Change OMNIMATE® Power LLF 7.50/90

1. General Overview

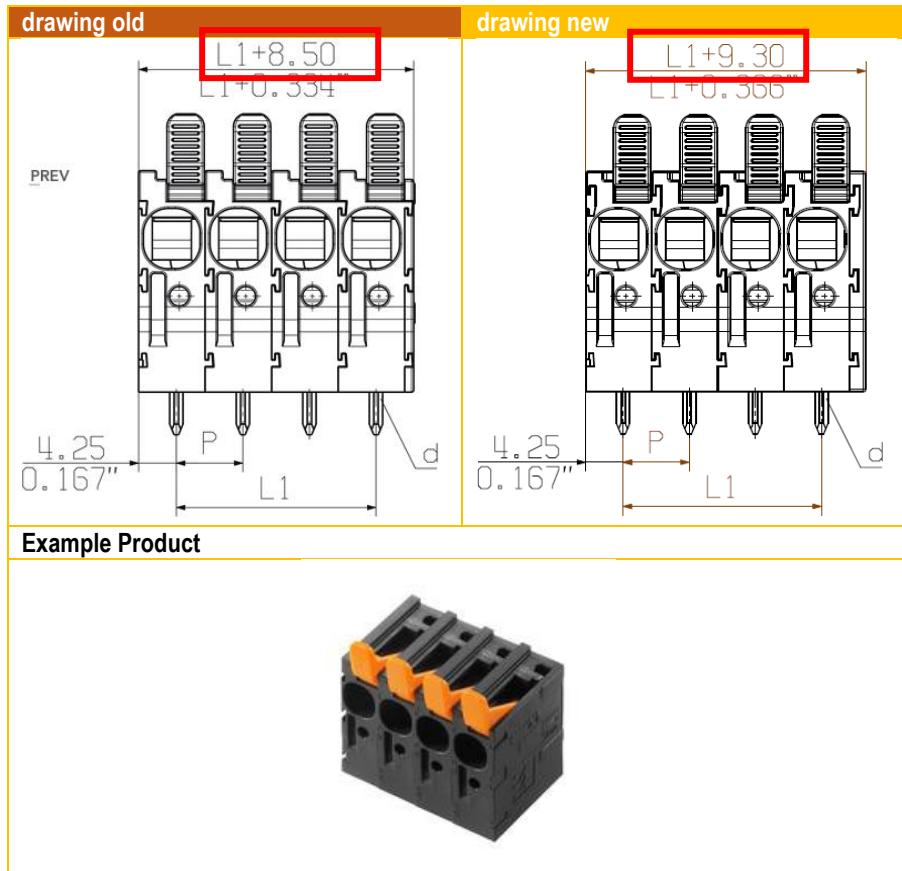
To harmonize the dimensions of the LLF / LLFS product families, we have adapted the width of the LLF 7.50/90 to that of the LLFS.
